**HORIZONTAL DIRECTIONAL DRILL ANALYSIS
NORTH POTTSTOWN PIKE CROSSING
PADEP SECTION 105 PERMIT NO.: E15-862
PA-CH-0212.0000-RD
(SPLP HDD No. S3-0370)**

**NORTH POTTSTOWN PIKE CROSSING
PADEP SECTION 105 PERMIT NO.: E15-862
PA-CH-0212.0000-RD
(SPLP HDD No. S3-0370)**

Proposed Modification to Construction Methods Resulting from Additional Investigation

Re: **Sunoco Pipeline L.P. – Pennsylvania Pipeline Project (Mariner East II)**
Chapter 102 Permit No. ESG 01 000 15 001 Modification Request Two
Request for additional LOD associated with revised pipeline installation technique
North Pottstown Pike-HDD S3-0370
West Whiteland Township, Chester County, PA

SUNOCO PIPELINE, L.P.
HORIZONTAL DIRECTIONAL DRILL
N POTTSTOWN PIKE
PENNSYLVANIA PIPELINE PROJECT

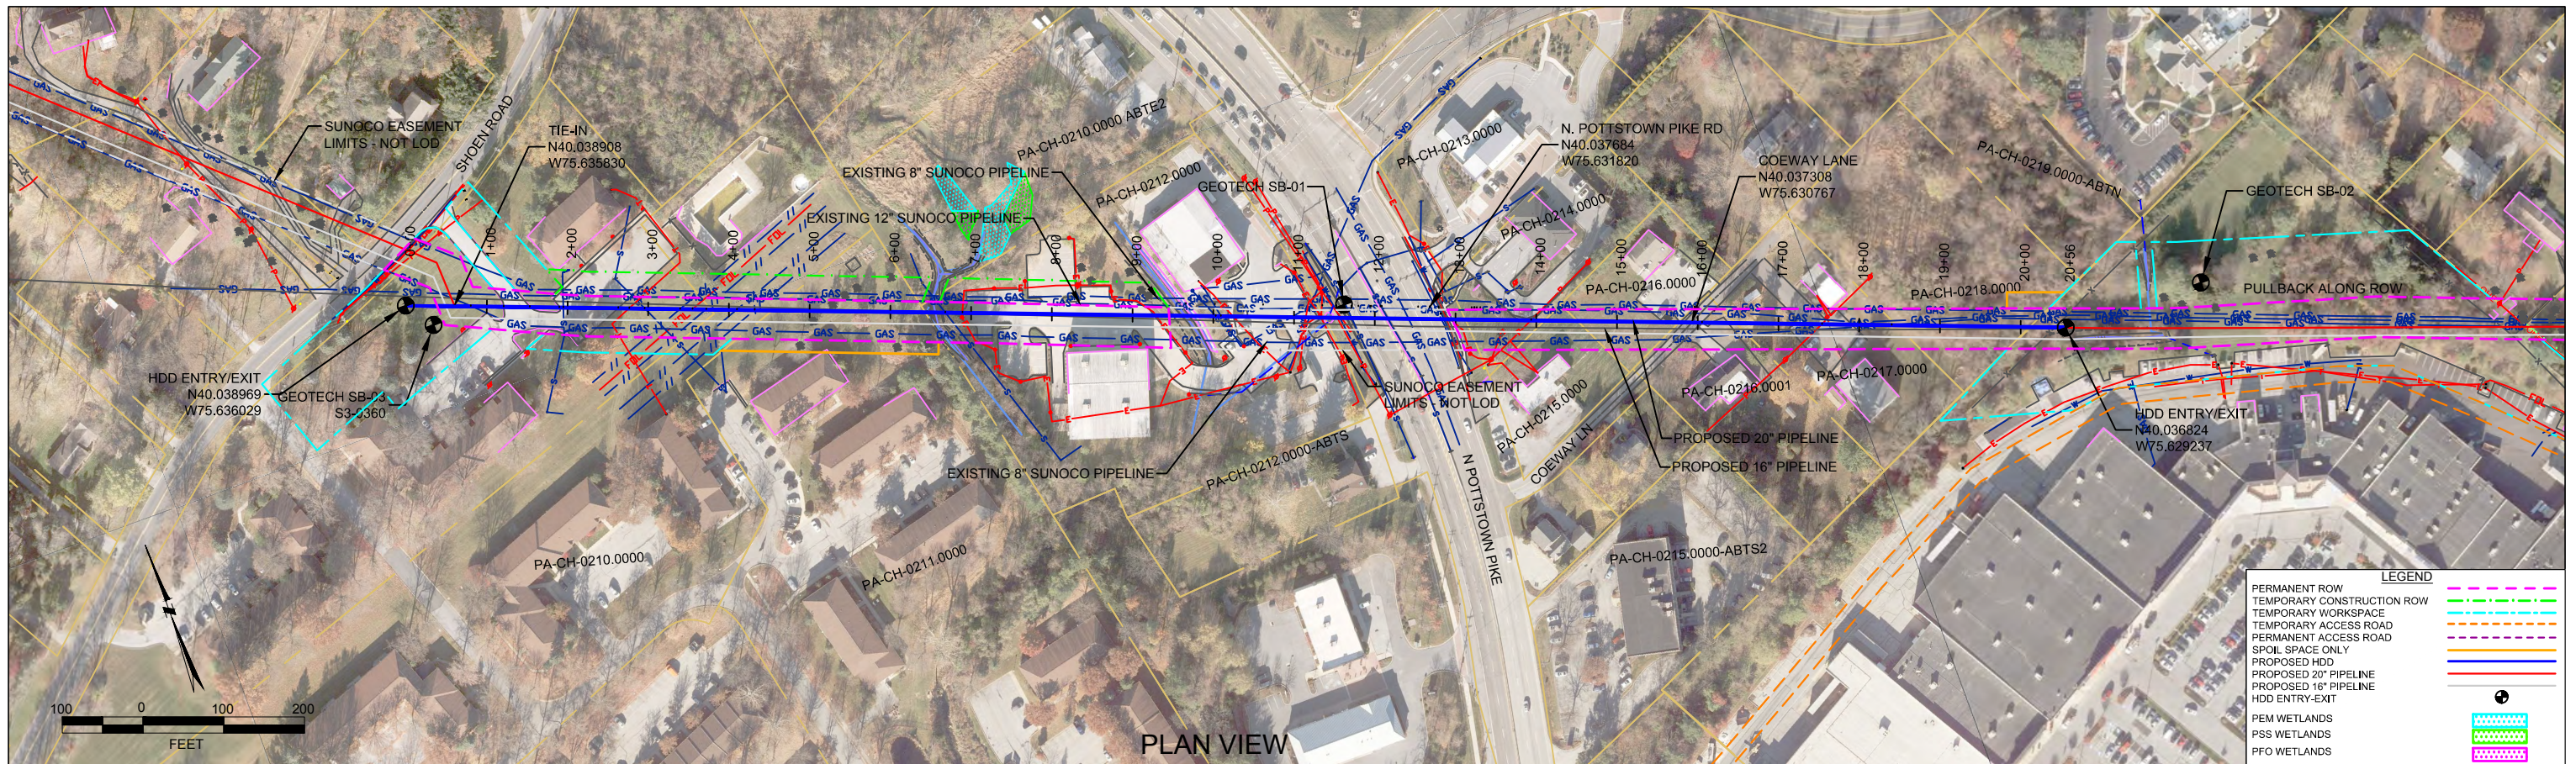
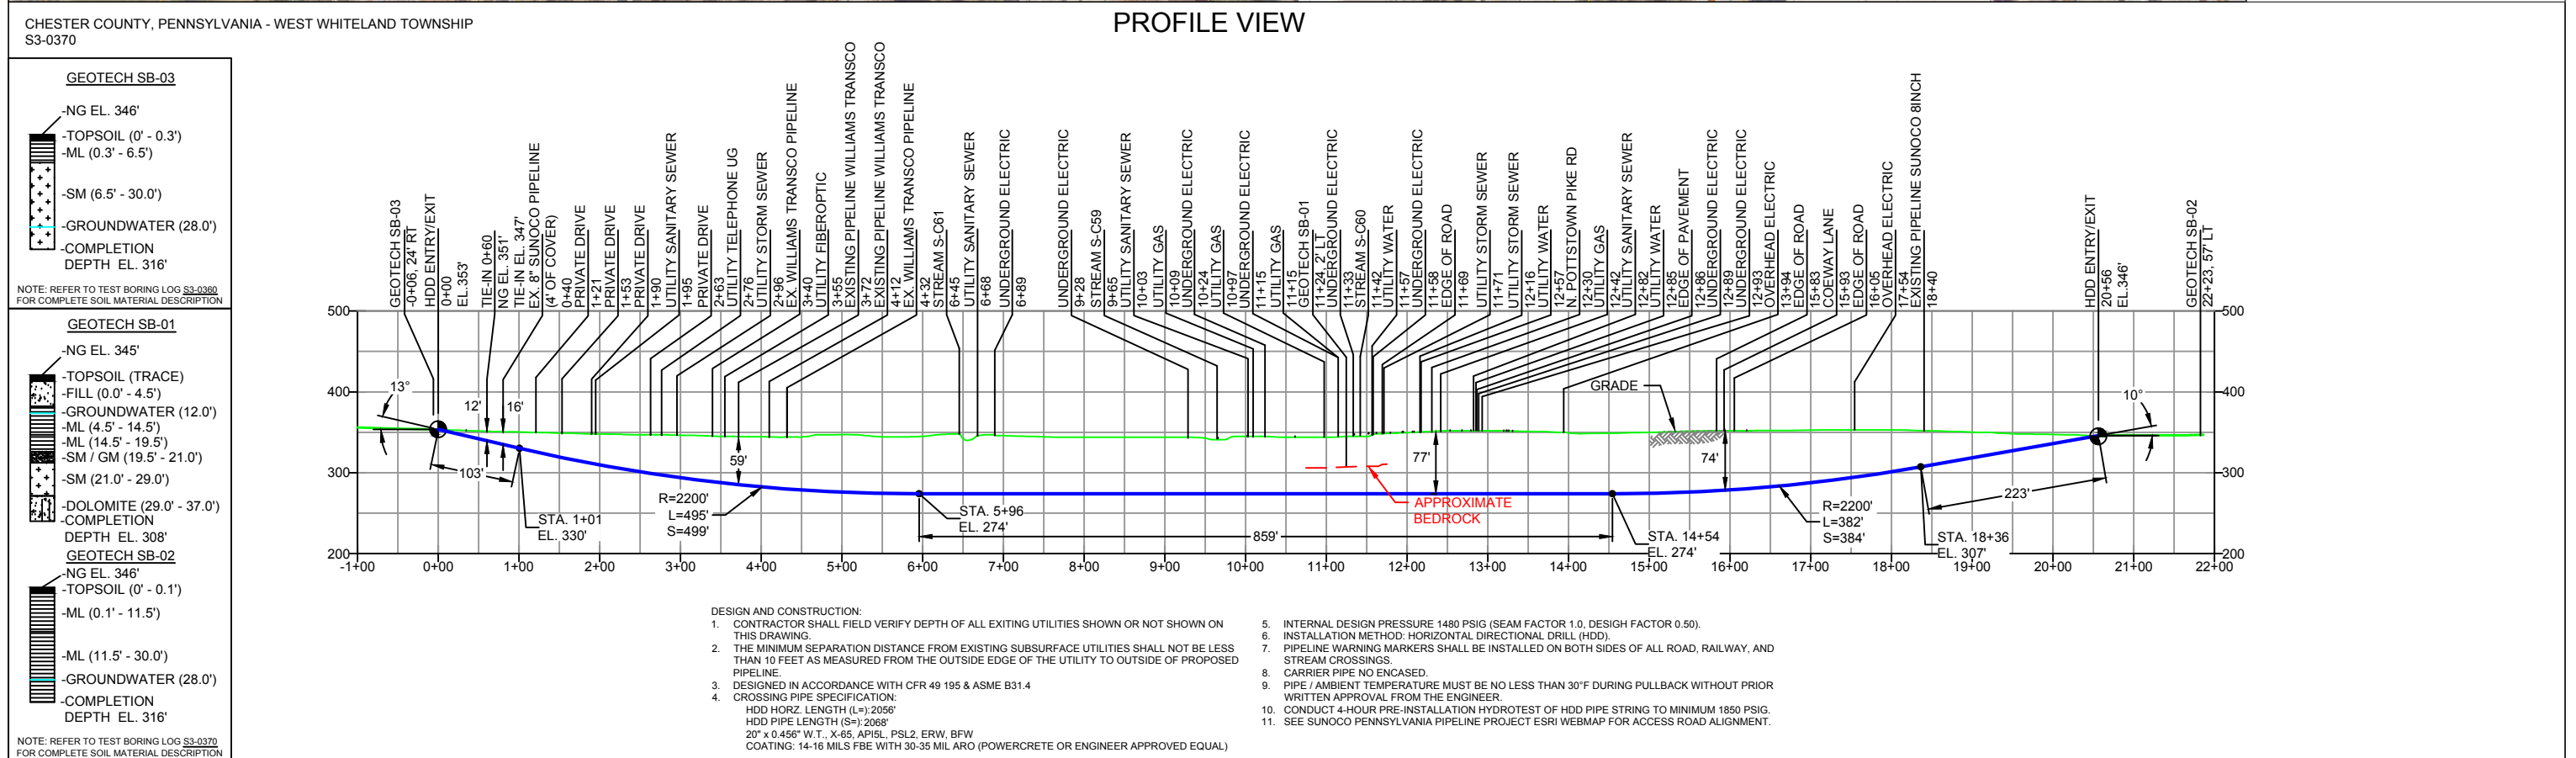
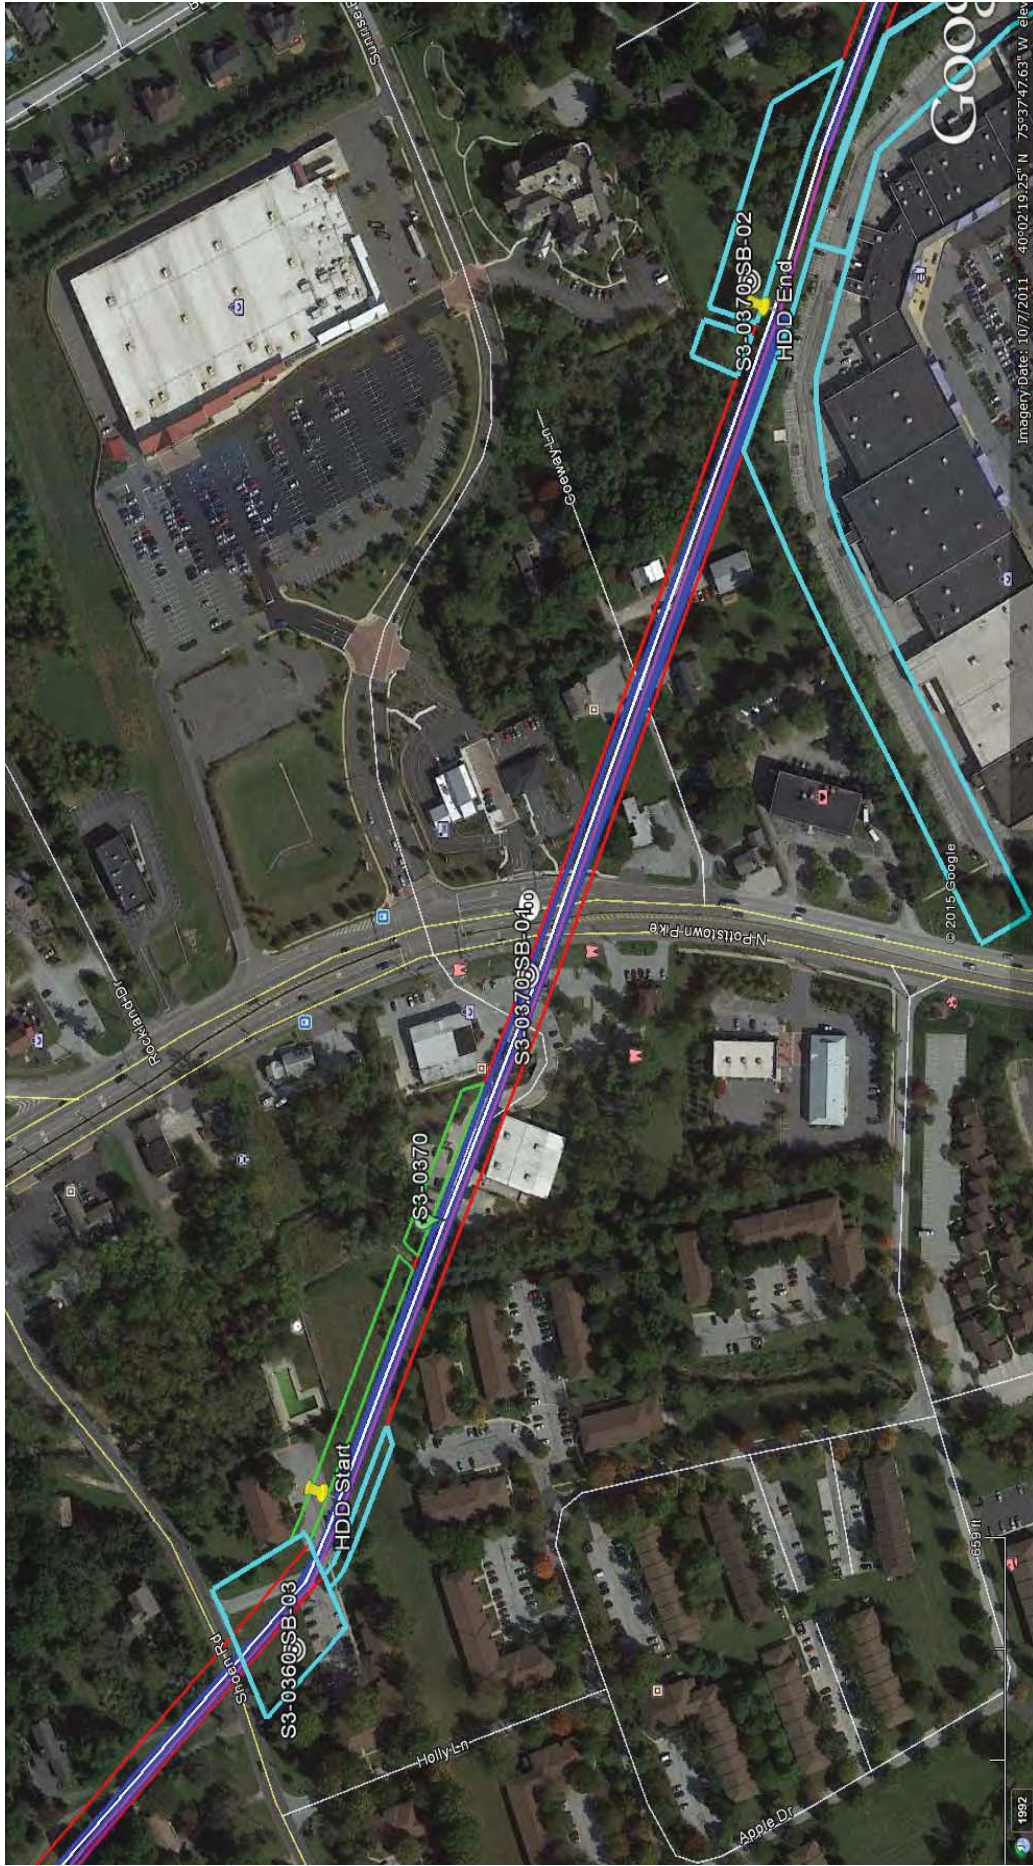
As a result of further studies conducted by SPLP, the plans for pipeline installation by HDD in this area have been changed to open cut and conventional bore due to concerns with the underlying geology.

As a result of further investigations, this HDD will be abandoned, and a conventional construction plan has been developed and submitted to the Pennsylvania Department of Environmental Protection (PADEP) for authorization, or by concurrence to this HDD reanalysis. A copy of the permit modification materials is included as Attachment 2.

SPLP is requesting that PADEP to approve a change in the proposed installation methodology for the previously proposed HDD to an open cut trench crossing and four conventional bores. SPLP performed further investigation of the proposed HDD design and options for redesign of the HDD profile. A shallower HDD was determined to not be feasible due to the changes in topography/elevation along the route. As is discussed above and in greater detail in the hydrogeologic evaluation report in Attachment 1,

The conventional bores will be added at: Stations 15083+50 to 15085+50 (CH-0209 Parking Lot), Stations 15088+50 to 15089+50 (Stream S-C61), Stations 15092+00 to 15093+00 (Stream S-C59), and Stations 15093+50 to 15096+00 (Stream S-C60 and North Pottstown Pike). The pipelines in the remainder of the areas within the formerly proposed HDD will be installed using conventional open trench methods.
